AMENDMENTS TO THE DRAWINGS

REMARKS

This Amendment is in response to the Office Action mailed June 30, 2005. Claims 1-8 have been amended. Claims 9 and 10 have been added.

Fig. 5
PRIOR ARTFig. 6
PRIOR ART

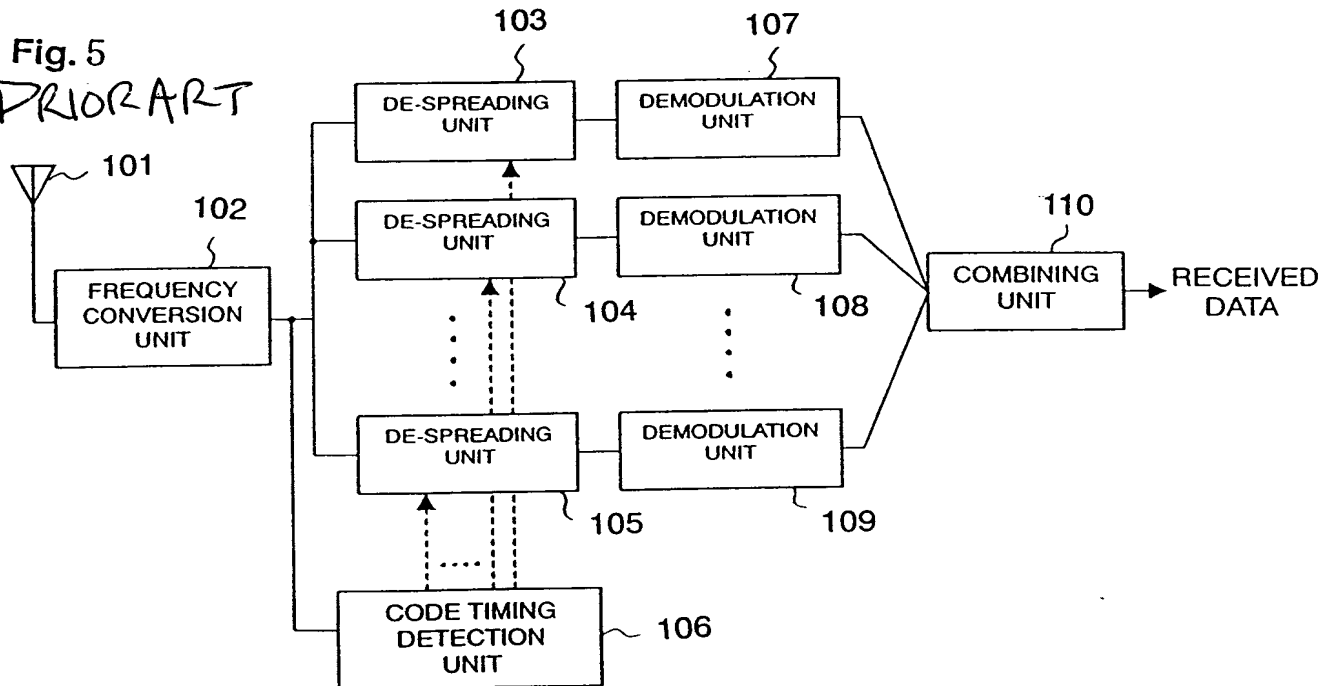
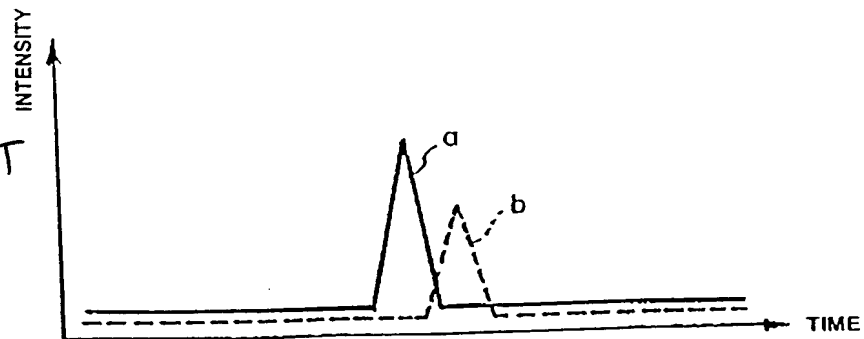
The attached sheets of drawings include changes to Figs. 5, 6 and 7. These sheets, which include Figs. 4-9, replace the original sheets including Figs. 4-9. In Figs. 5-7, the legend – Prior Art – has been added.

Figs. 5-7 have been designated by the legend – Prior Art – to comply with paragraph 1 of the Office Action.
